UNC Charlotte Phase 16

Addendum #4

Revision Narrative

2021-09-08

E-008

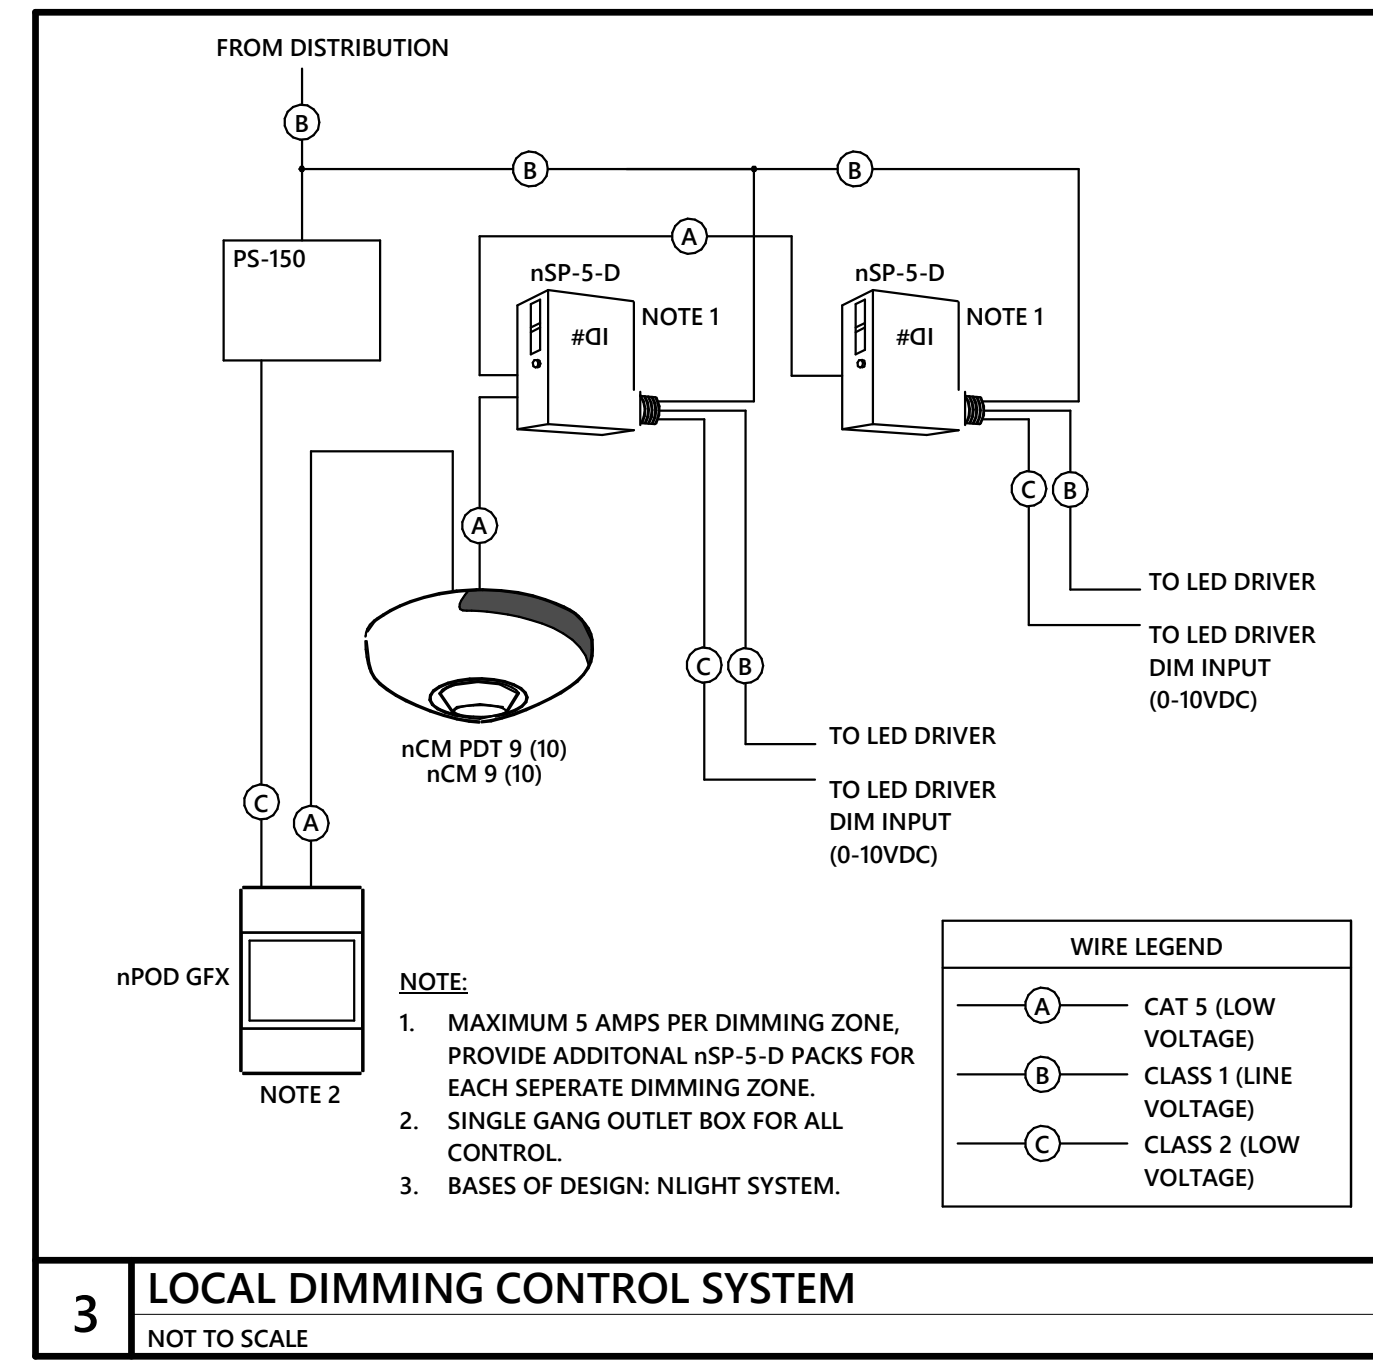
E-008 – Revisions for clarifications on access control details.

E-009

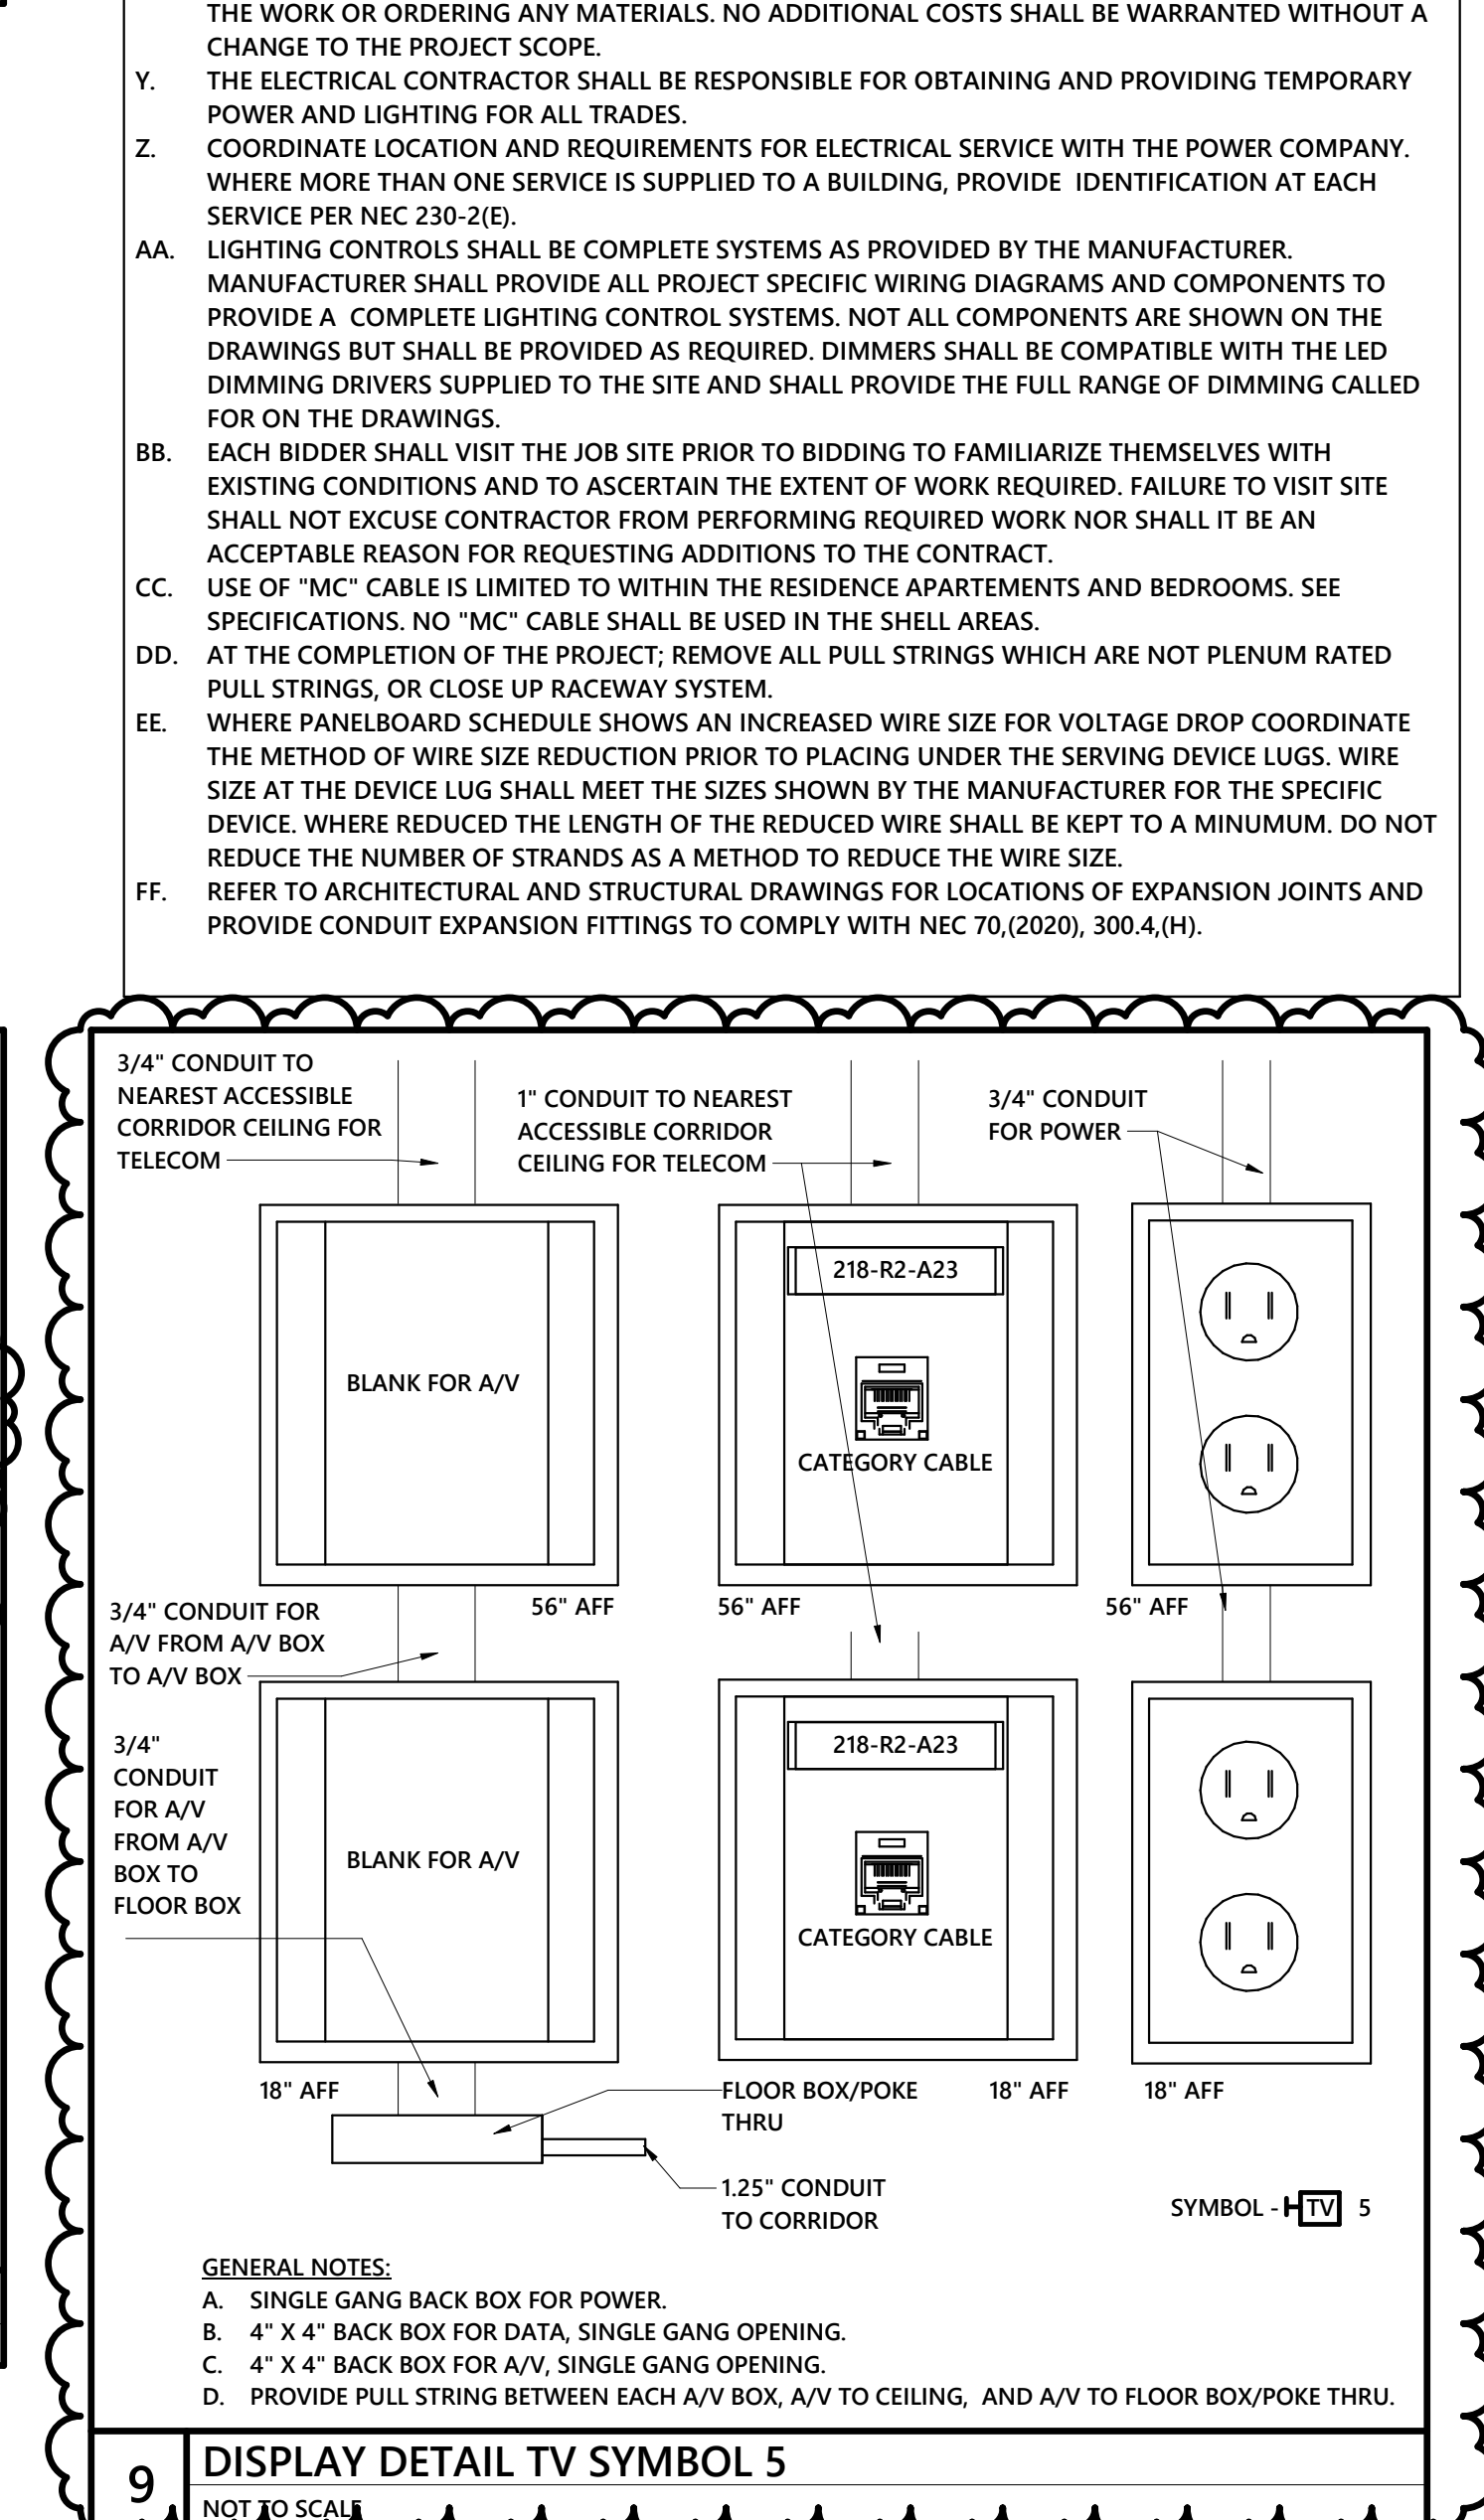
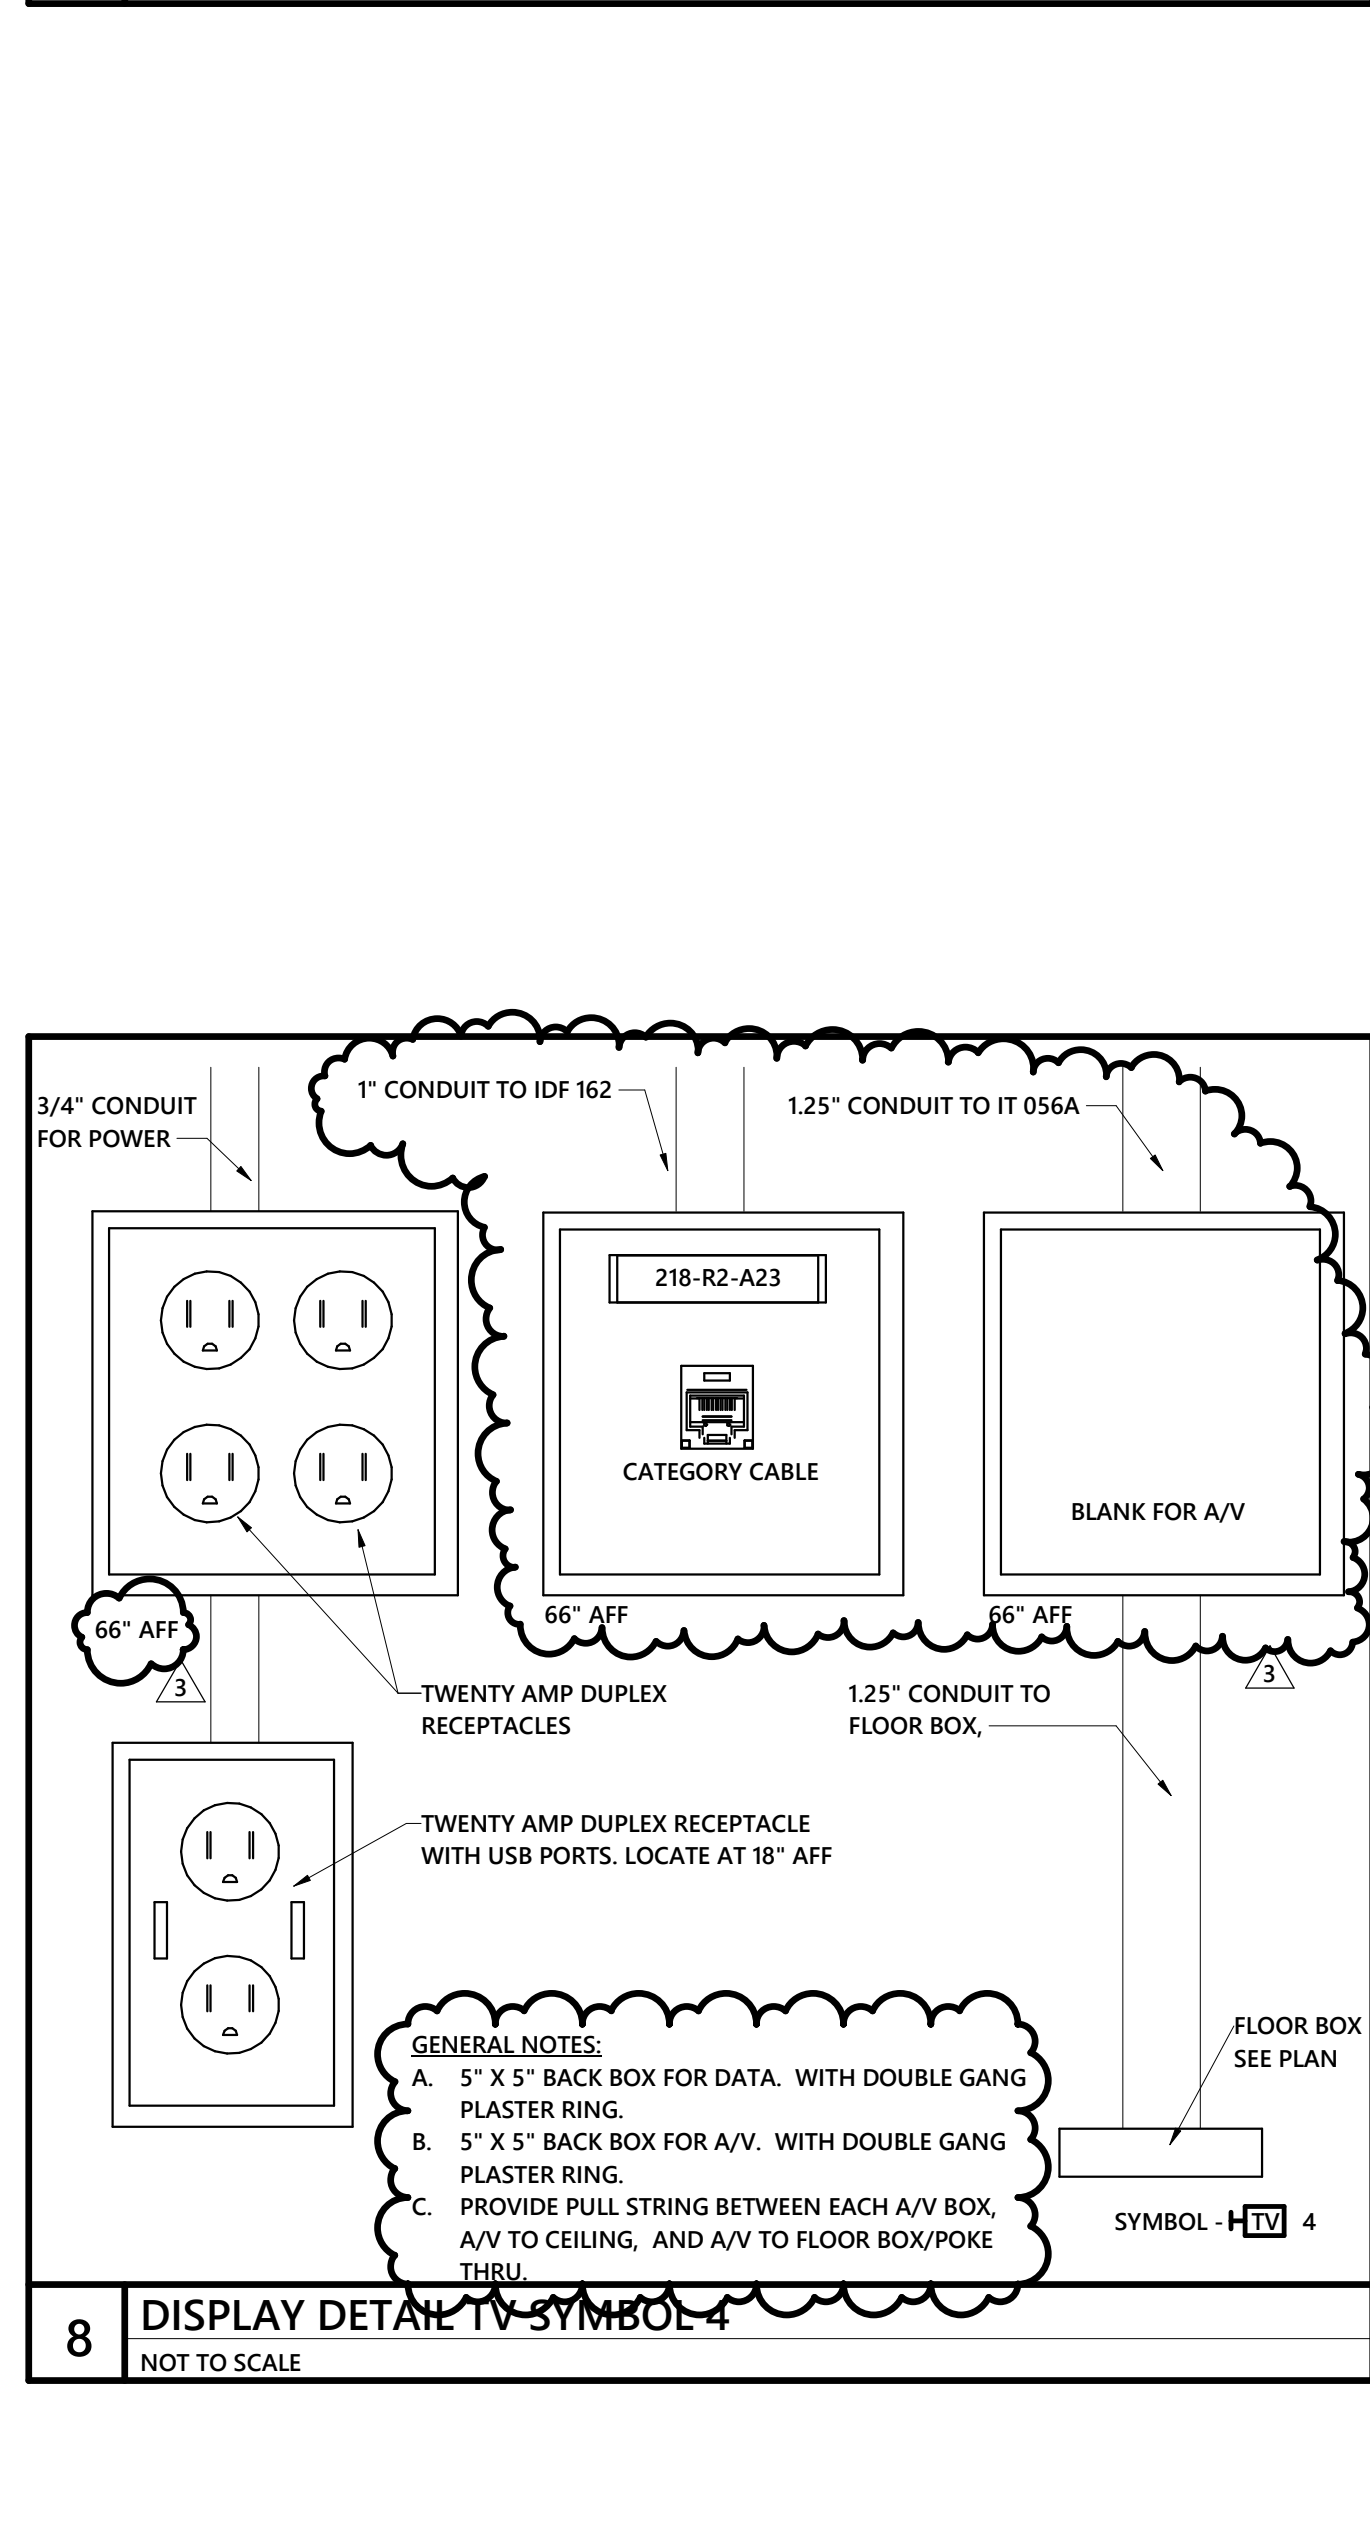
E-009 - detail #9 updated (TV 5). Detail #7 updated (TV 3). Detail #8 updated (TV 4). Detail #6 updated (TV 2).

Rooms affected by #7: LOUNGE 050, Lounge 036, CONFERENCE 151, LOUNGE 254, LOUNGE 354, LOUNGE 454

Rooms affected by #9: STUDY 030, STUDY 110, STUDY 130, STUDY 136, STUDY 210, STUDY 230, STUDY 289, STUDY 310, STUDY 330, STUDY 389, STUDY 410, STUDY 430, STUDY 489, STUDY 510, STUDY 530, STUDY 589.

Rooms affected by #8: CLASSROOM 055

Rooms affected by #6: LOBBY COR008
